Dexter Axle has determined that a condition potentially involving motor vehicle safety may exist in vehicles produced by certain trailer manufacturers beginning February, 2000 through August, 2000. We are in the process of determining which customers have received product that may be involved.

## PRODUCT ALERT

**NOTICE OF PRODUCT RECALL # 00E-051**

**Reference: RECALL NO. # 00E-051**

ARE AR-62 - Rivets

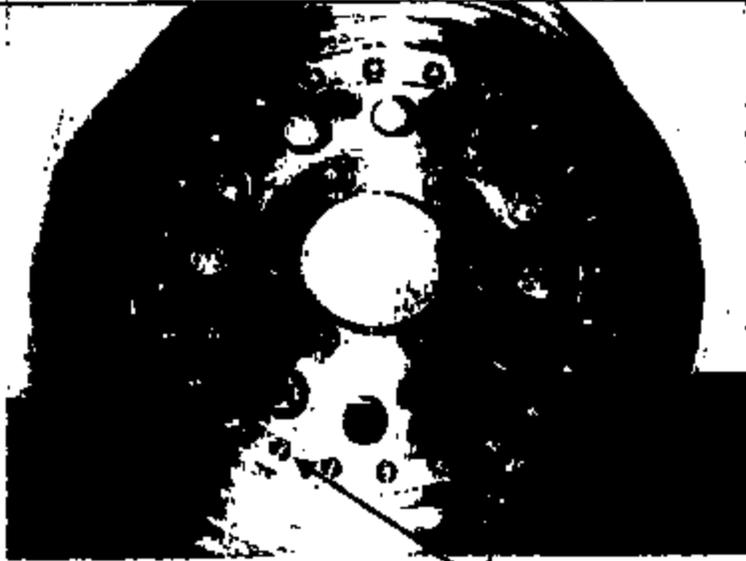
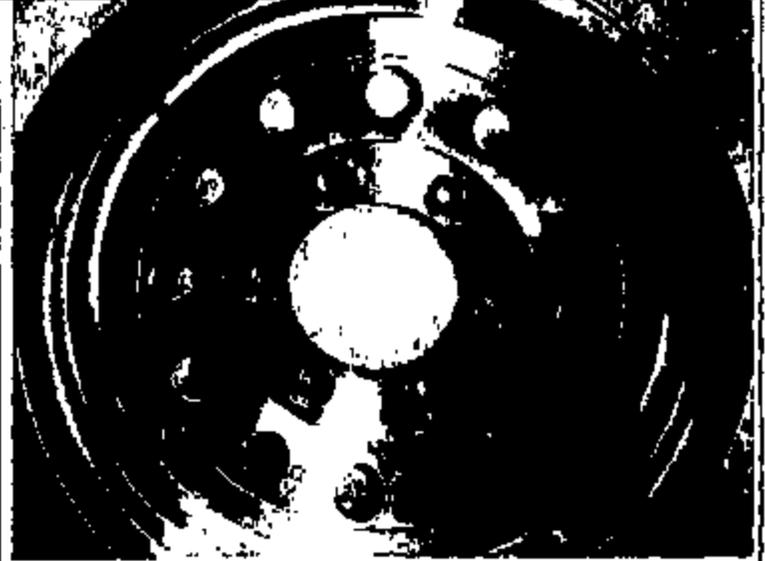
It has come to our attention that many of our valued customers believe they are continuing to receive the AR-62 aluminum wheel from Tredit branches. It is our understanding that Tredit has the AR-62 aluminum wheel in inventory, but has discontinued any sale of this particular aluminum wheel to Dexter Axle customers. Any Dexter Axle customer who is continuing to purchase aluminum wheels from Tredit must ensure the new designed aluminum wheel is received.

Attached are pictures to assist you in determining the difference between the AR-62 aluminum wheel and the new designed aluminum wheel.

Figure #1

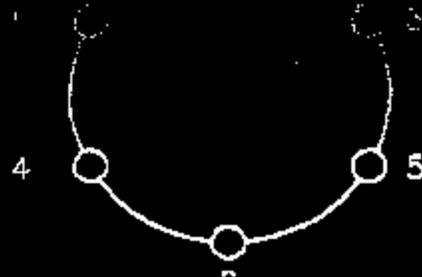
1. Determine if trailer is fitted with aluminum wheels or steel wheels. If the trailer does not have aluminum wheels, no further action will be required. For trailers with aluminum wheels, proceed to step #2.
2. Jack up and support the vehicle as recommended by the manufacturer.
3. Remove the aluminum wheels and inspect the hub face. If the hub face area of the brake drum looks like fig. #1, no repairs will be necessary.
4. Re-install the wheels and wheel nuts. Tighten nuts in the sequence shown in fig. #2 to 90 to 120 ft. lbs. torque.  
If the hub face looks like fig. #3, proceed to step #4.
